**PVC CLAYPOOL BUILDING SCOPE DESCRIPTION**

UPDATE 3/20/19

The following list of scope items is to be used together with the attached DSA approved set of plans.

**CLAYPOOL BUILDING RECONSTRUCTION**  
PALO VERDE COLLEGE, NEEDLES CENTER  
PALO VERDE COMMUNITY COLLEGE DISTRICT  
725 WEST BROADWAY STREET, NEEDLES, CALIFORNIA 92363

SHEET NO. **A2.3**

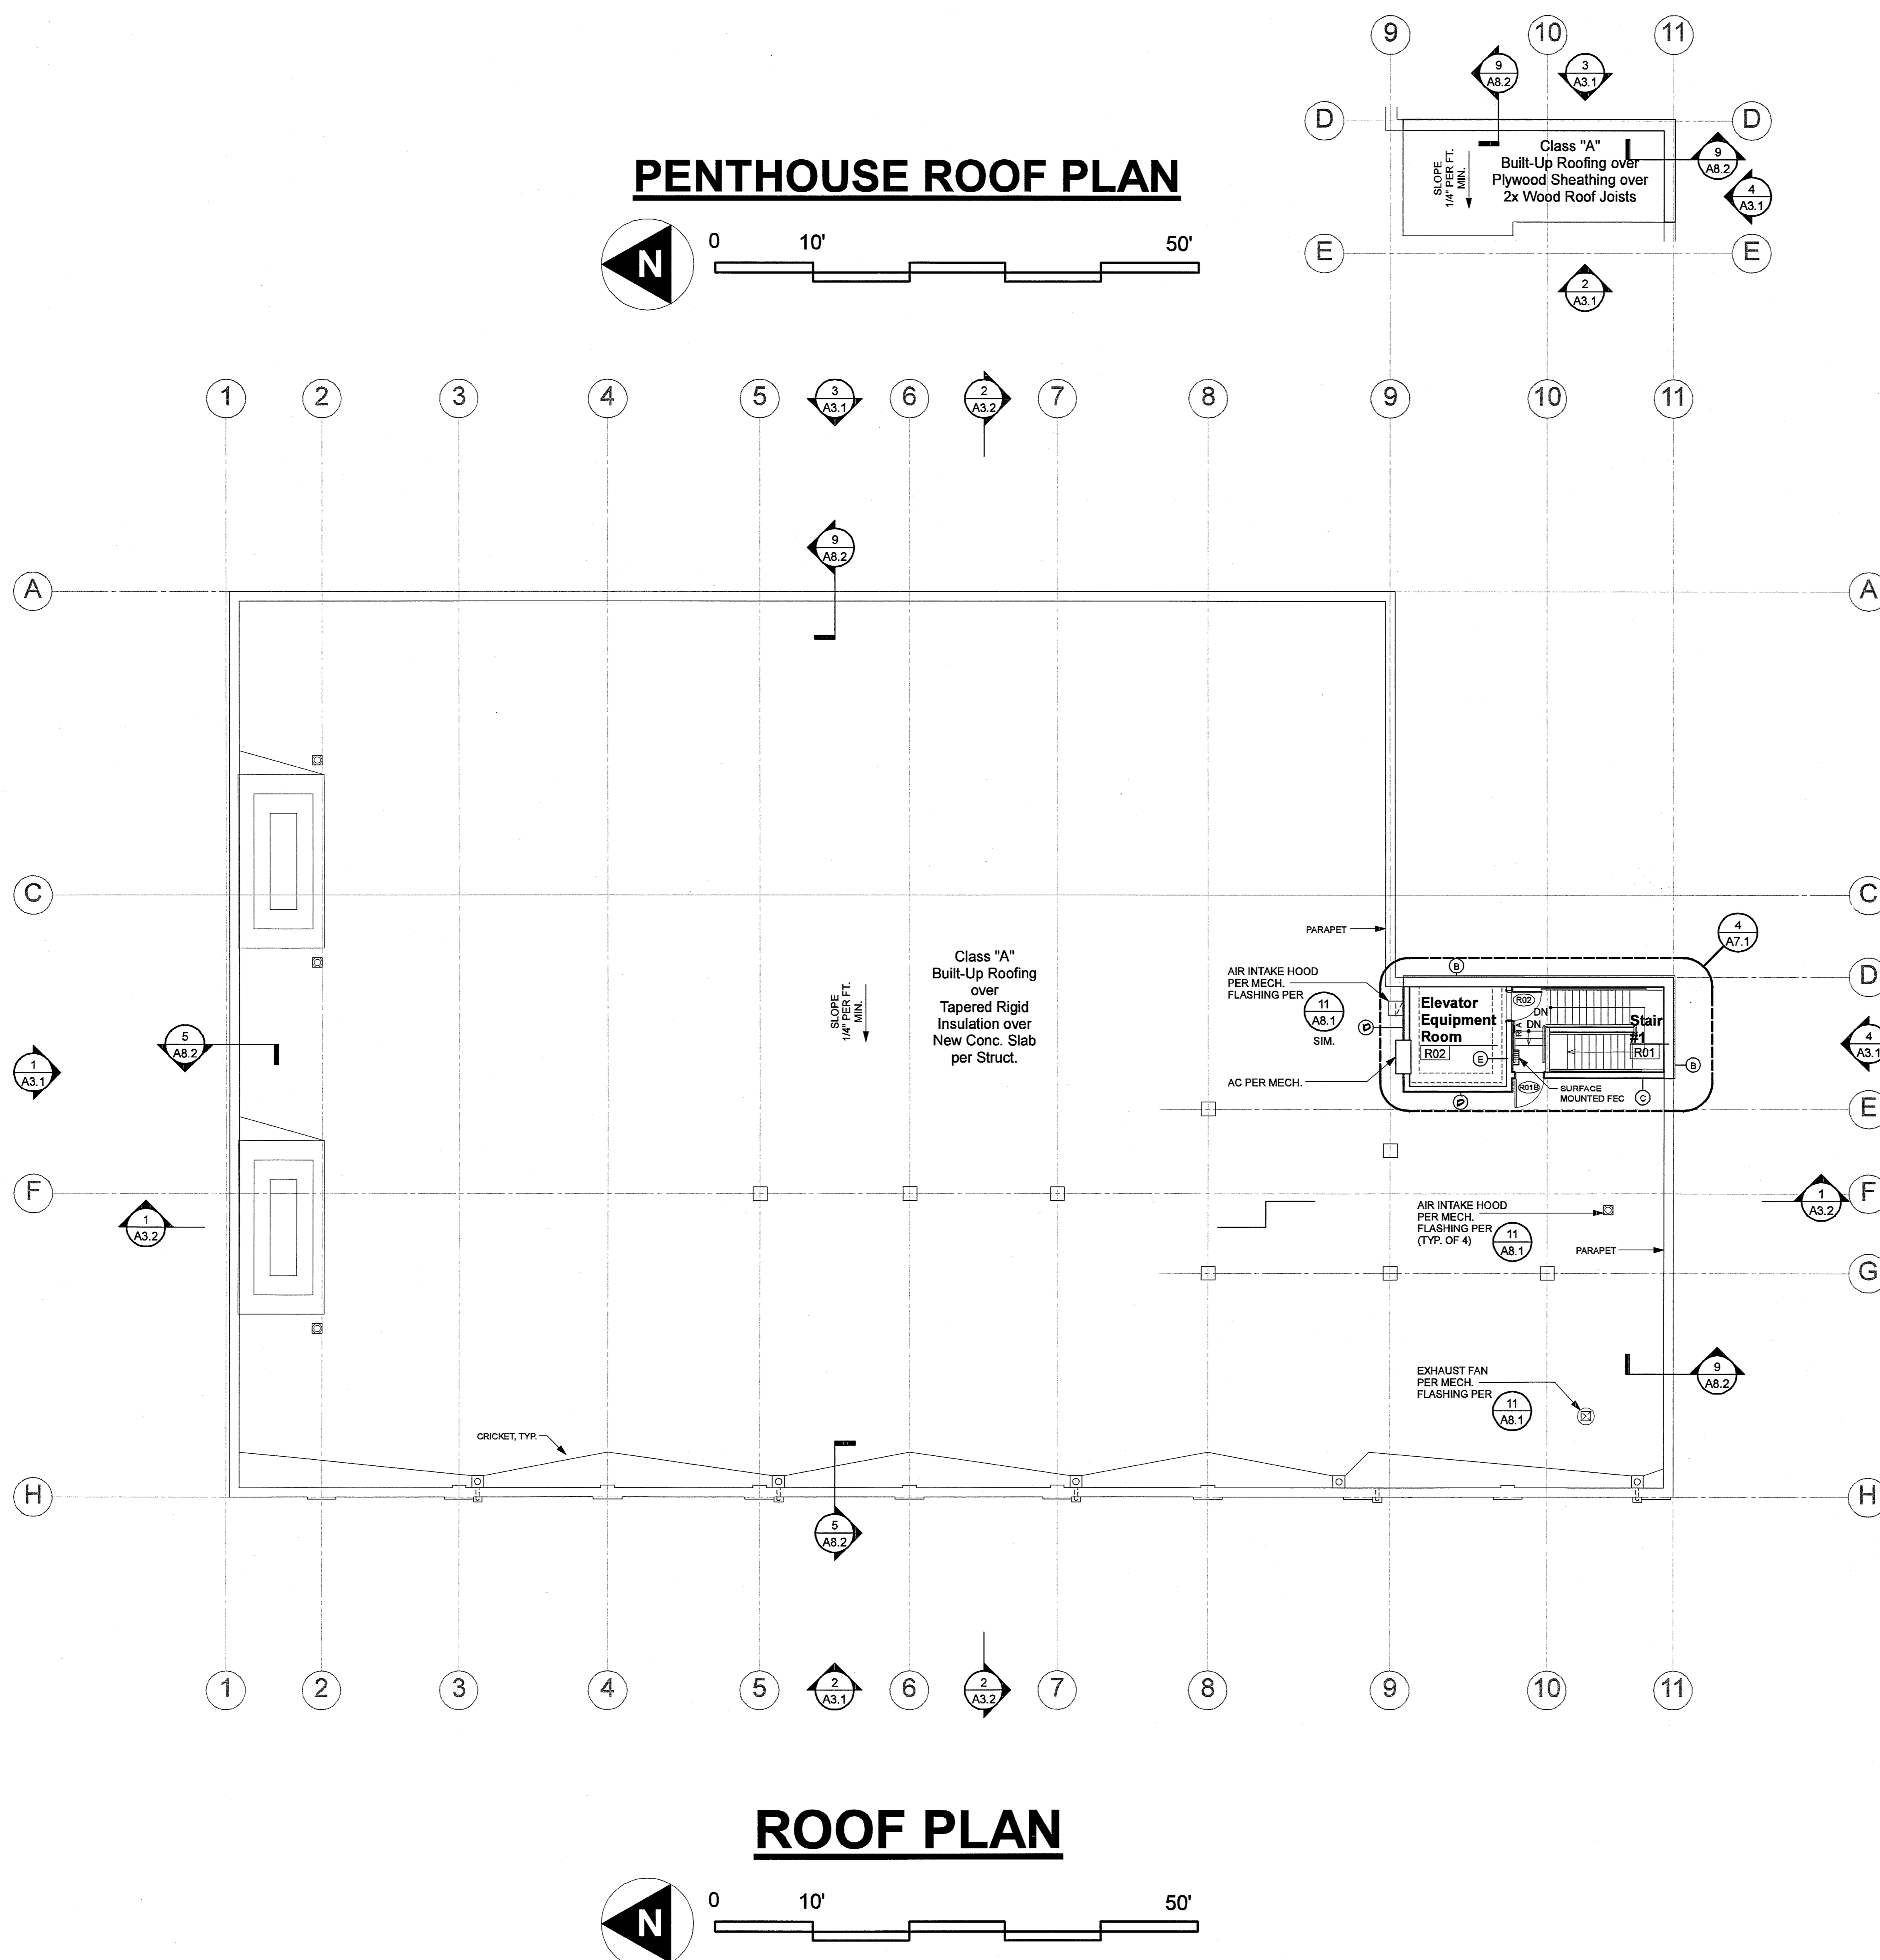
<b>INSPECTOR</b>						
I-002	A2.3	Line 10 (mezzanine)	2/A9.1 - Verify slab thickness and verify that correct anchorage was used	<b>ALLOWANCE #4: CONTRACTOR TO CONFIRM EXISTING WALL BASE CONNECTION AT GRID 10 ON SHEET A2.3. PROVIDE 3/16" DIA. THRU-BOLT @ 32" O.C. PER HANDWRITTEN NOTE ON 2/A9.1.</b>		Slab between Lines 10 and 11 was measured at +/- 2.5" thick. Shot-pins shot through track multiple locations, as noted in May 1 review.
I-003	S-3 (1st Floor Frm'g)	3.5 / A-B	HSS 10x and stiffening rod (12A/S7)	Sawcut slab above, provide channel to allow for placing the 1" threaded rod as shown on drawing.		Opened wall, verified installation of all the work shown on the approved drawings, EXCEPT for the 1" threaded rod (12/S-7)
I-005	S-3 (1st Floor Frm'g)	8 to 9 on H	21/S-6 Verify addition of C12 and end-plates to the ext'g beam	Add C12 as shown on approved set		Reference in detail is to a cut joist near 9/H. Did not see this Channel when looking at open ceiling from below.

SHEET NO. **A6.1**

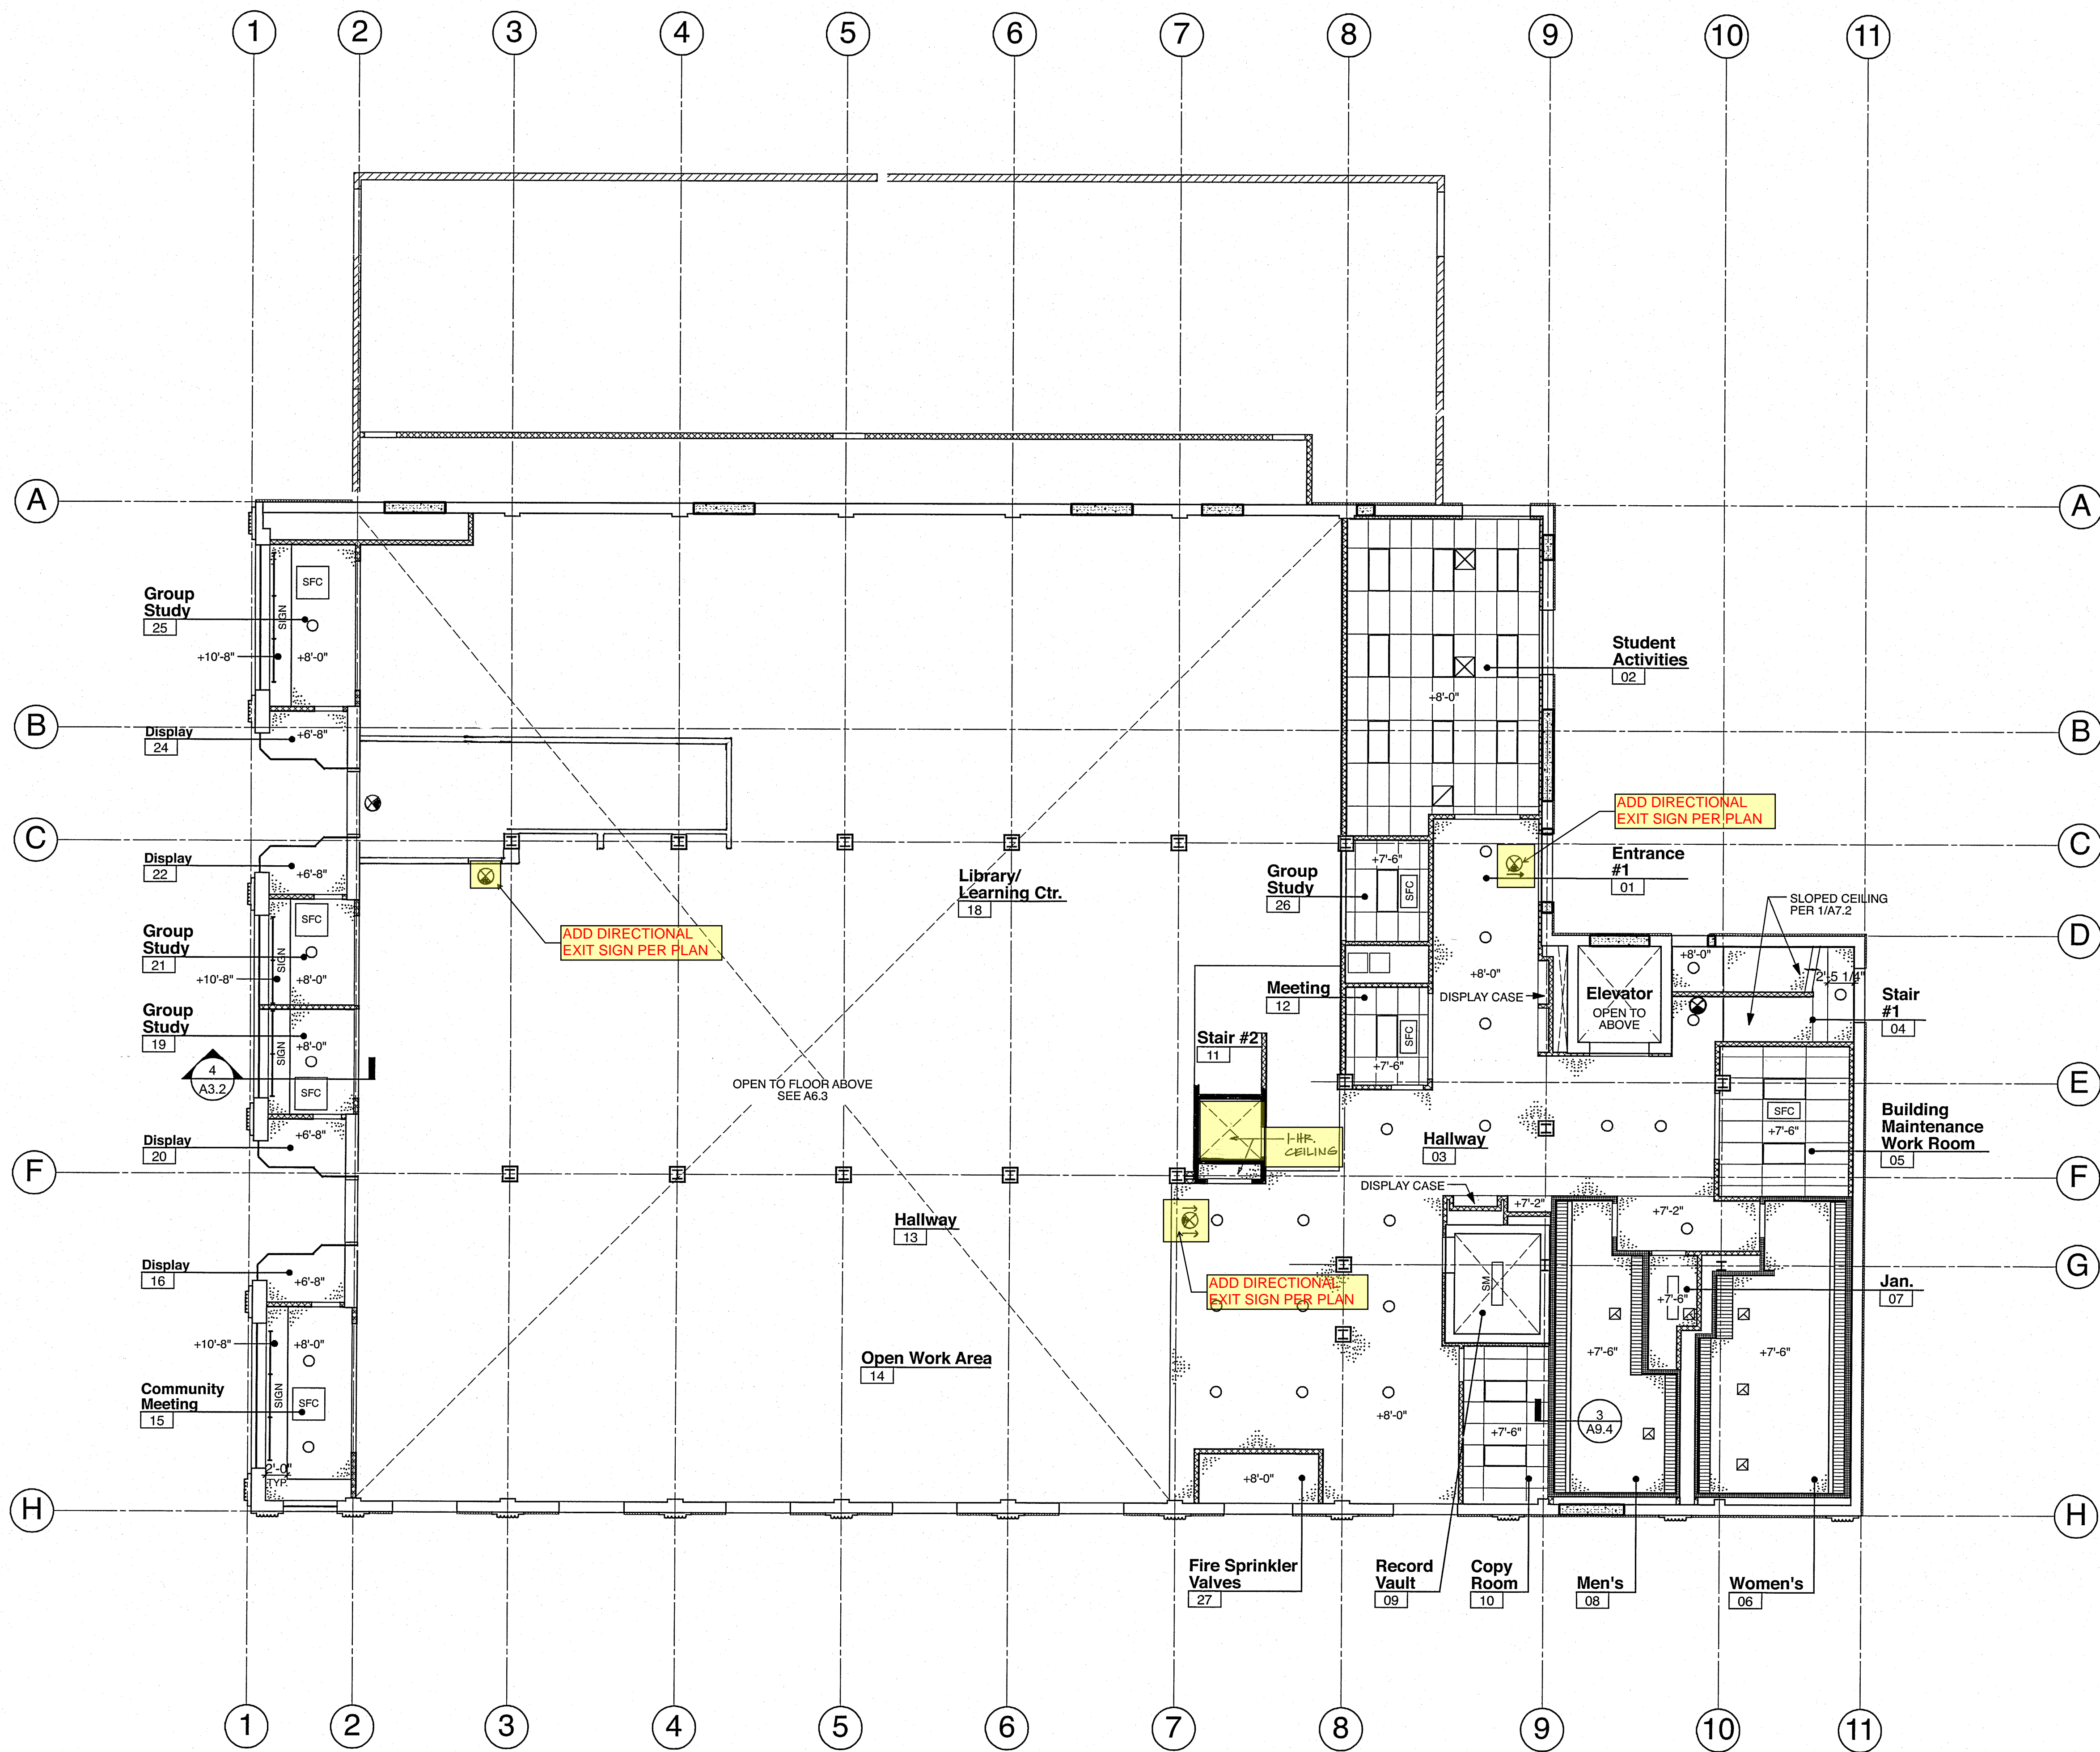
I-029	A6.1 RCP	Basement Classrooms/Offices	Lay-in Panel Ceilings	<b>Every lay-in panel ("T-Bar") ceilings is deficient in one or more of the following: Missing the correct number of seismic struts, splay-brace wires, and/or perimeter wires. Some perimeter wires have been cut to allow mechanical work, and must be restored. The perimeter angle must be secured to the wall at two adjacent walls, and left un-secured on the opposite wall(s).</b>		ref: Sheet A9.3 in its entirety
I-030	A6.2 RCP	1st Floor Classrooms/Offices	Lay-in Panel Ceilings	<b>Every lay-in panel ("T-Bar") ceilings is deficient in one or more of the following: Missing the correct number of seismic struts, splay-brace wires, and/or perimeter wires. Some perimeter wires have been cut to allow mechanical work, and must be restored. The perimeter angle must be secured to the wall at two adjacent walls, and left un-secured on the opposite wall(s).</b>		ref: Sheet A9.3 in its entirety
